<b>XtremeAir GmbH, Harzstr.2, D-39444 Hecklingen</b> Tel: +49 39267 60999 0, Fax: +49 39267 60999 20 www.xtremeair.de info@xtremeair.de	Document No. <b>SB-2013-002</b>
		Issue: A.01
DOA-Nr.: EASA.21J.360	<b>Service Bulletin SB-2013-002</b>	Date: 15.4.2013

Subject:	Fuel Vent
Aircraft type affected:	XA41 and XA42
Serial numbers affected:	MSN 01 through 06, and 101 through 114
Compliance:	Mandatory
Time of Compliance:	next 100 hours
Purpose:	To notify owners of above aircraft of a potential flight safety condition.
Background:	The transparent fuel vent hoses installed in the aircraft listed above have unsatisfactory ageing characteristics. The present service bulletin provides instructions for the installation of improved fuel vent hoses.
Manpower:	It is estimated approximately 25-30 man-hours will be required to accomplish this bulletin.
Materials:	<p>The following material should be ordered through <a href="mailto:spares@xtremeair.de">spares@xtremeair.de</a>:</p> <ul style="list-style-type: none"> <li>10 m blue vent line</li> <li>(1) ea. firewall assy. XA42-7130-180</li> <li>(1) ea. thermal blanket XA42-7130-202</li> <li>(1) ea. bulkhead fitting fuel XA42-2820-216</li> <li>(2) ea.

**Picture 2**

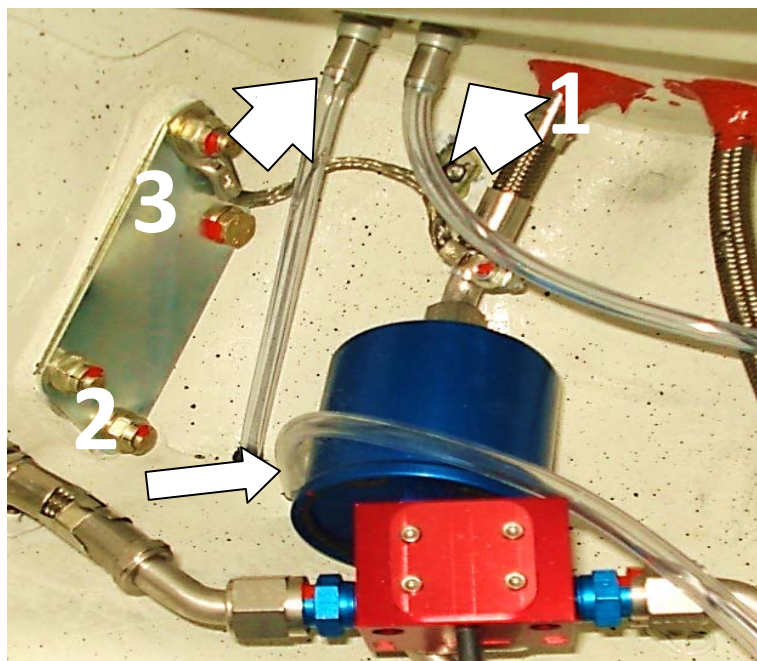
10. Heat the new hose end (100-150°C) and push it 7mm over the tank wall fitting. Check the area of the fuel line for foreign objects.
11. Bond the cover for the fuel line in the forward lower R/H fuselage with RTV 106.

**Picture 4**

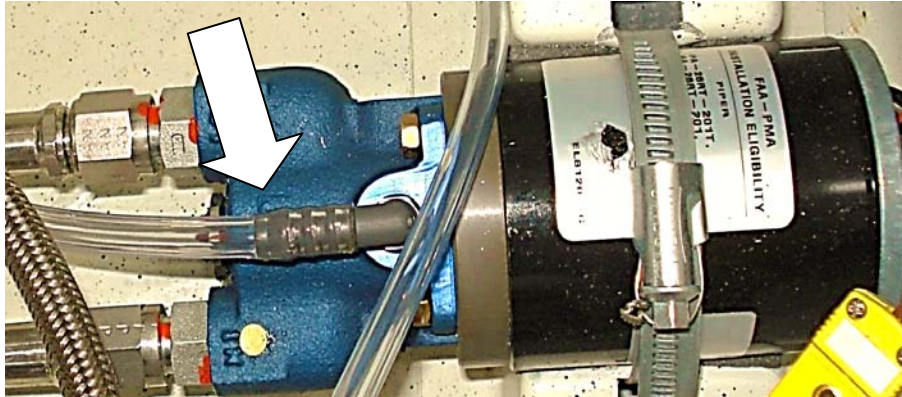
17. Remove the vent hose from the fuel pump carefully with a cutter knife. (Picture 4)  
**Attention:** Do not damage the fitting.

**Picture 5**

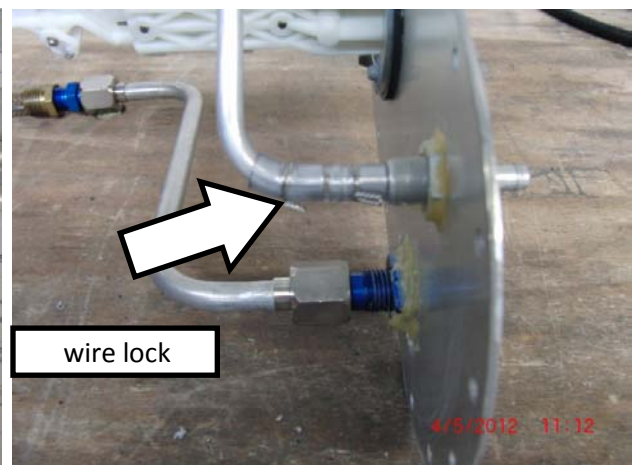
18. Transfer the length of the old hoses to the new hoses.  
 19. Install all new vent hoses to the appropriate fittings.  
 20. Remove the hand-hole covers (XA42-2820-151/154) in the wing root ribs.  
 21. Remove the vent pipe (XA42-2820-218) from the cover and remove the clear vent hose with a cutter knife.  
 22. Install the new blue hose.  
**Attention:** The hose must be pushed on the pipe minimum 15 mm on both sides!  
 Additionally wire lock using 0,8mm MS20995C-32 (Pictures 5 and 6)

**Picture 9**

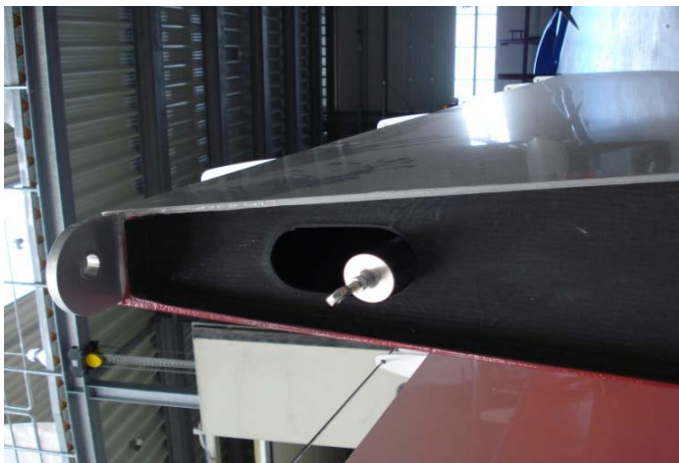
55. Temporarily secure the electrical cable on the wing lh/rh with tape. (Picture 9)
